**The W Nursing School
Neshoba General
Philadelphia, MS**

Addendum No. 2

June 10, 2026

This addendum forms a part of the contract documents and modifies the original plans and specifications dated June 4, 2026.

3 FURNITURE PLAN
1/4" = 1'-0"

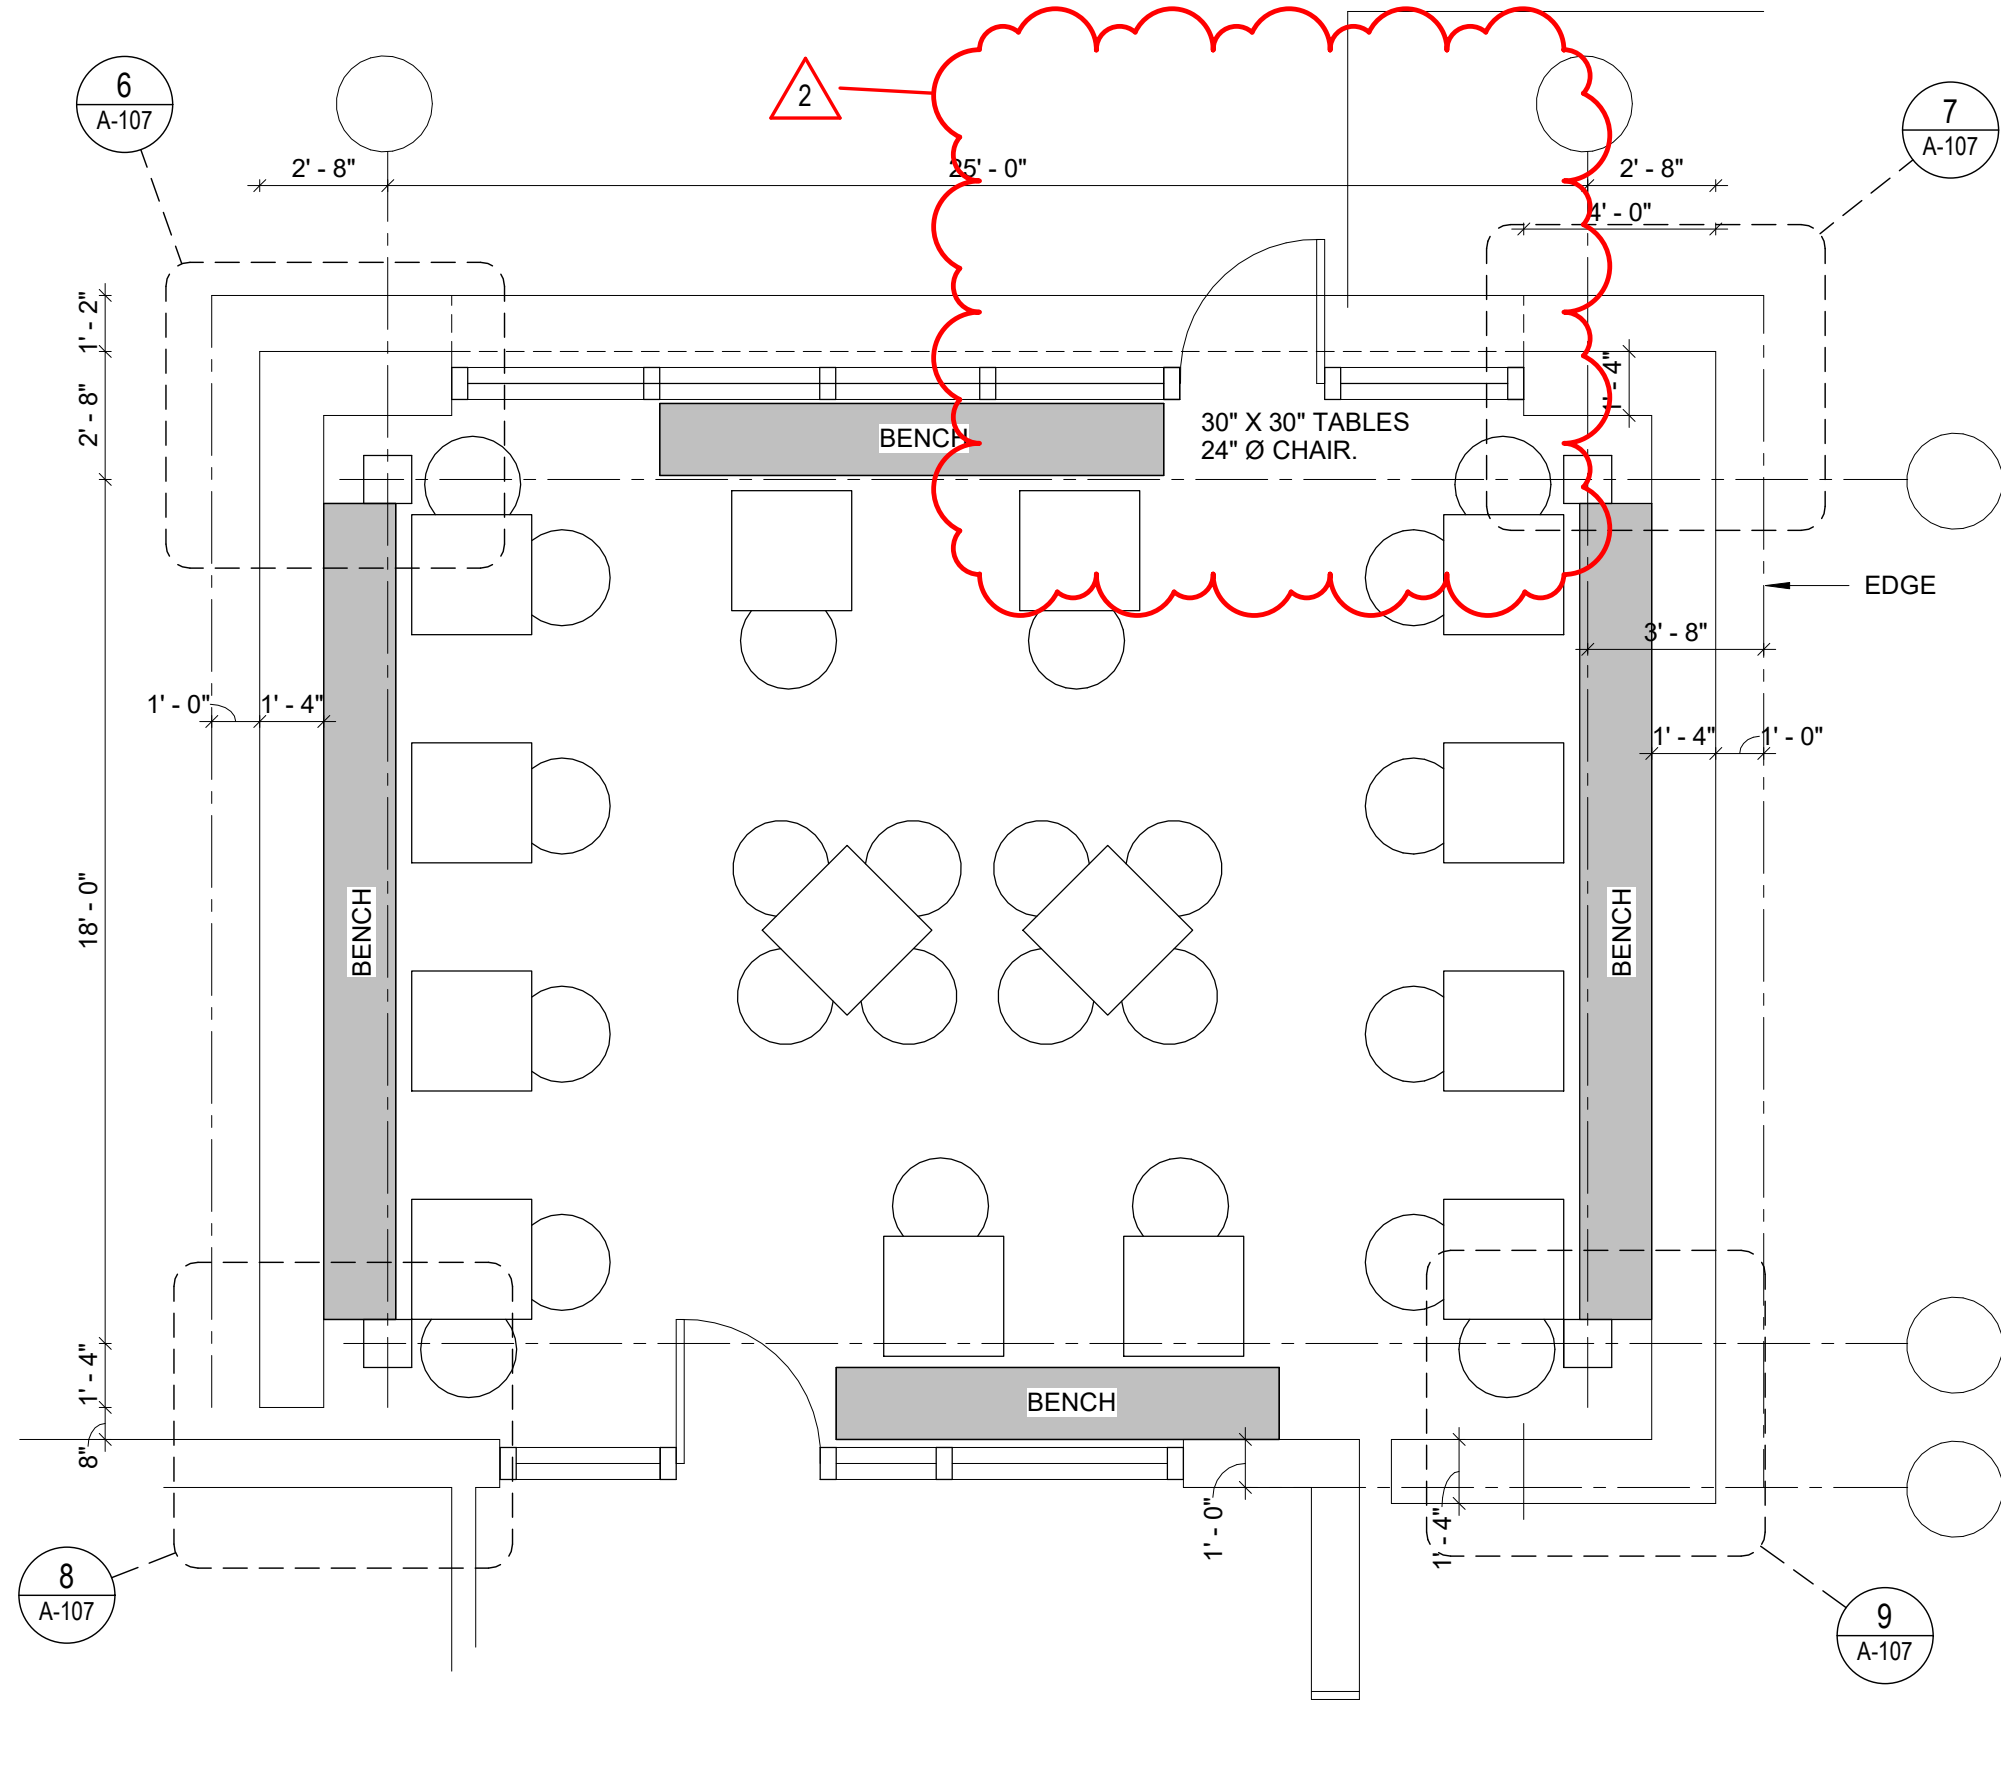
Item 2.6: Sheet A-107

Note: See clouded configuration 11/A107 of the condense units at the north end of the project.

5A WALL DETAIL 5A A403
1 1/2" = 1'-0"

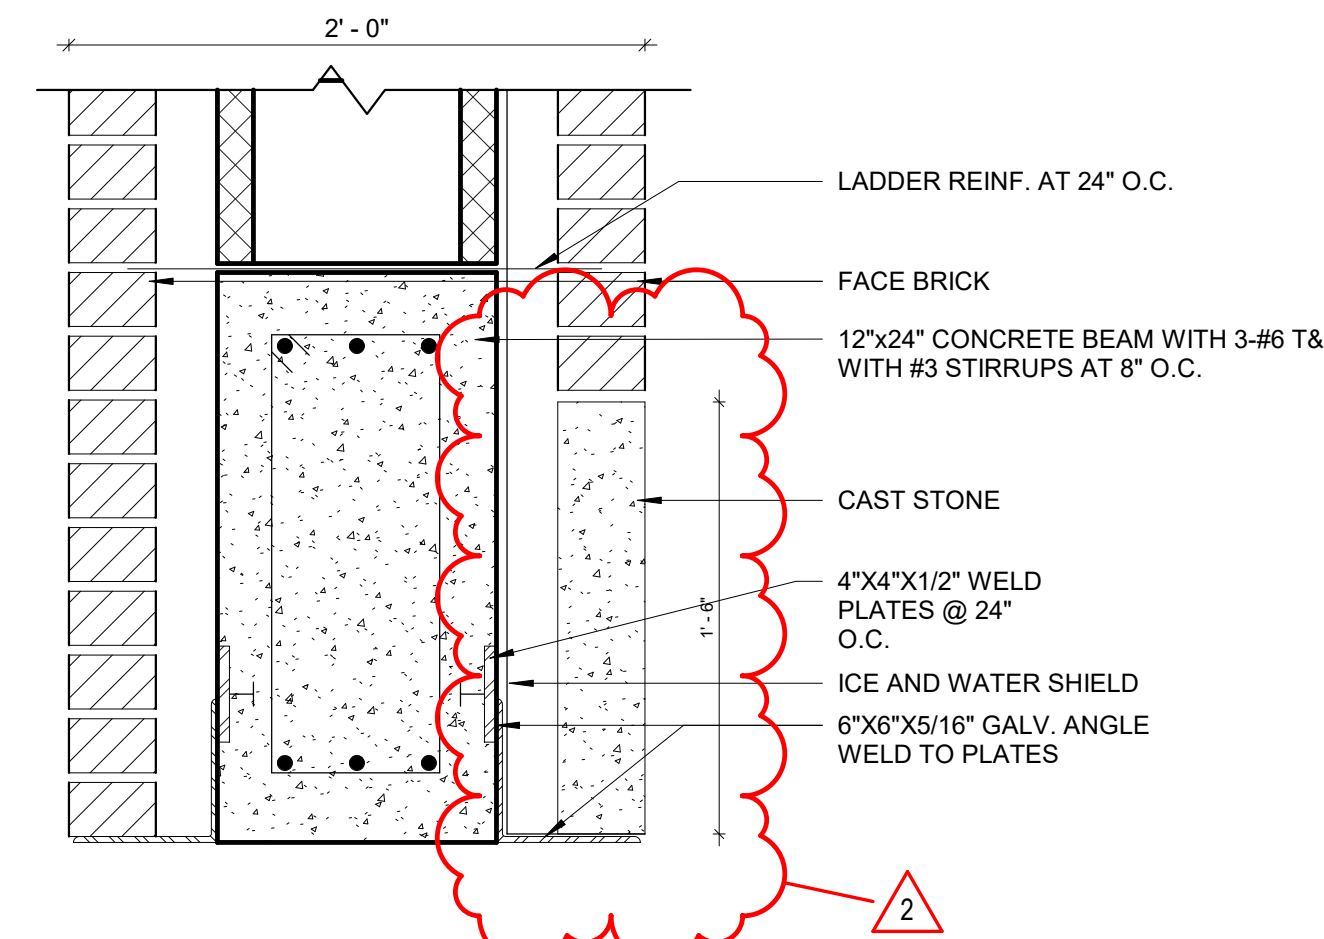
Item 2.8: Sheet A-403

Note: See clouded Detail 4A/A403 to include cast stone.
